## DEFECT INFORMATION REPORT #638

### **DEALER SERVICE INSTRUCTIONS Safety Recall #638 – Secondary Hood Latch Bracket**

Reference: NSA-111bdh; 95V-056

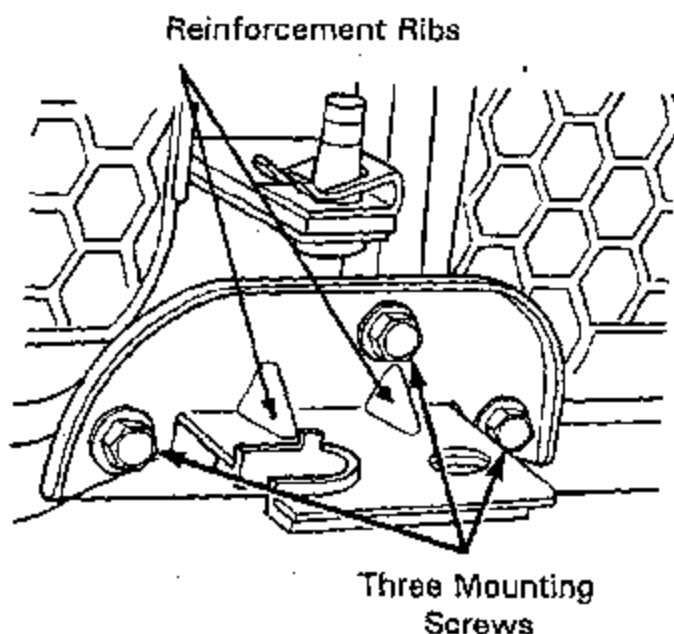
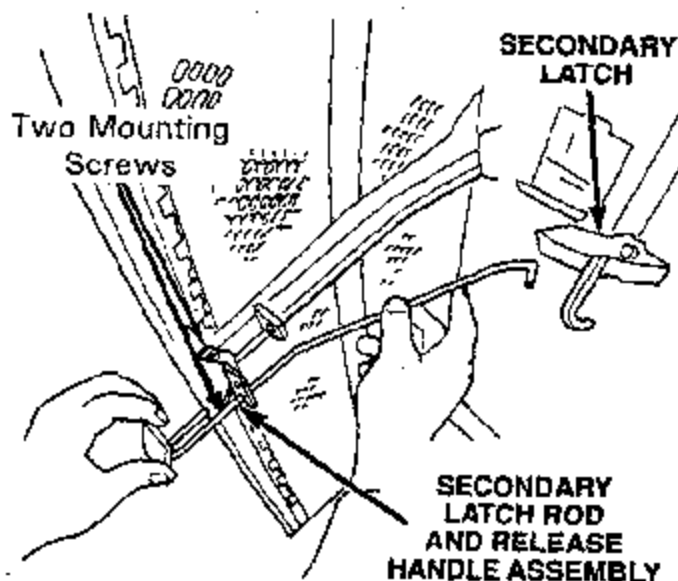
**Q2. Furnish an illustration of the hood rod and defective guide bracket involved in the recall. Furnish an illustration of the field remedy guide bracket and describe whether the field remedy guide bracket is different than the production remedy in place December, 1994. Describe any differences between the original 1994 production guide bracket and the December, 1994 production remedy.**

2. Furnish an illustration of the hood latch rod and defective guide bracket involved in the recall. Furnish an illustration of the field remedy guide bracket and describe whether the field remedy guide bracket is different than the production remedy in place in December 1994. Describe any differences between the original 1994 production guide bracket and the December 1994 production remedy.

- A2. The subject vehicle remedy guide bracket (figure 1) utilizes three mounting screws and additional reinforcement ribs for improved strength. The December, 1994 production remedy utilizes the same guide bracket as that used at the beginning of the 1994 model year (figure 2). The initial (and December, 1994 production fix) guide bracket is mounted with two screws and is bent at a 90 degree angle. The subject vehicle guide bracket (beginning late-January, 1994) is mounted with two screws and is bent at an 84 degree angle (figure 2). This six degree angle bracket modification reduces clearance between the hood latch rod and guide bracket and creates the potential for rod-to-bracket binding on the subject vehicles.
